Work Order ID 132903

Item Name: Fwd Crosstube - Mid Height 206L / L1 / L3 / L4, Blue

DRAWING NO. D206-667-147	TITLE CROSSTUBE ASS'Y (206L MID FWD)	REV. A	DART AEROSPACE LTD ENGINEERING ORDER		D.E.O. NO. D206-667-147-A-1	SHEET NO. SHEET 1 OF 1	SCALE NTS
DRAWN <i>Q</i>	CHECKED <i>ADS</i>	MFG. APPR. <i>JS</i>	APPROVED <i>MD</i>		DE APPR. <i>MD</i>		
DATE 11.07.15	DATE 11.07.20	DATE 11.07.21	DATE 11/07/21		DATE 11.07.21

DRAWING NO. D206-667-147	TITLE CROSSTUBE ASS'Y (206L MID FWD)	REV. A	DART AEROSPACE LTD ENGINEERING ORDER		D.E.O. NO. D206-667-147-A-2	SHEET NO. SHEET 1 OF 1	SCALE NTS
DRAWN AJS	CHECKED	MFG. APPR.	APPROVED		DE APPR.		
DATE 12.08.02	DATE 12.08.02	DATE 12.08.02	DATE 12.08.02		DATE 12.08.02	DATE 12.08.02

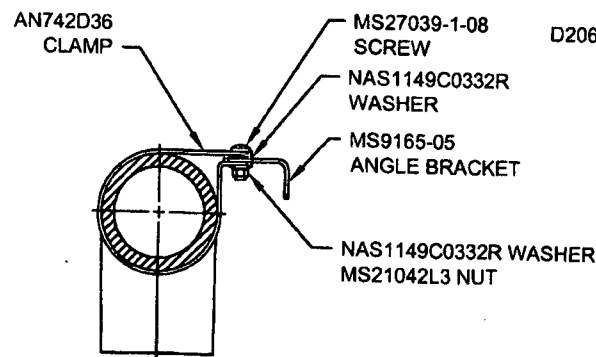
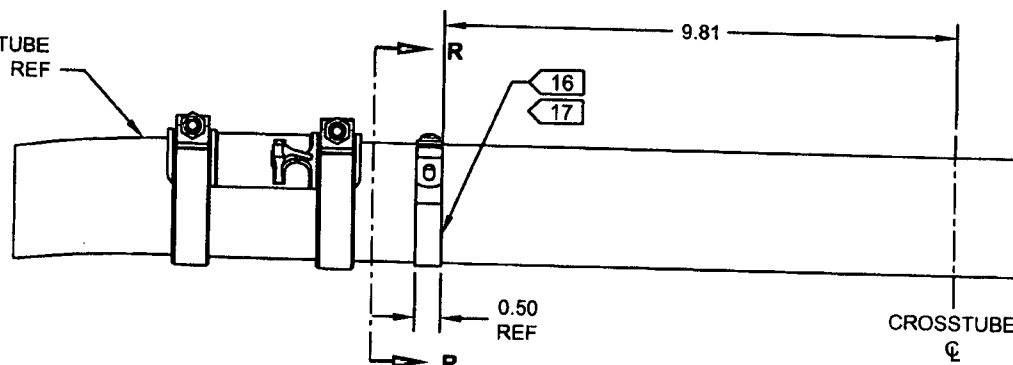
ADD ELECTRICAL GROUNDING STRAP

- 16) MASK AREA UNDER CLAMP PRIOR TO PAINTING
- 17) SEAL EDGES WHERE AN742D36 CLAMP MEETS WITH THE CROSSTUBE USING SIKAFLEX-241/-291 OR MIL-S-8802 CLASS B2 OR PROSEAL 890 SEALANT
- 18) PERFORM RESISTANCE CHECK TO ENSURE MAX RESISTANCE IS 10 MILLIOHMS
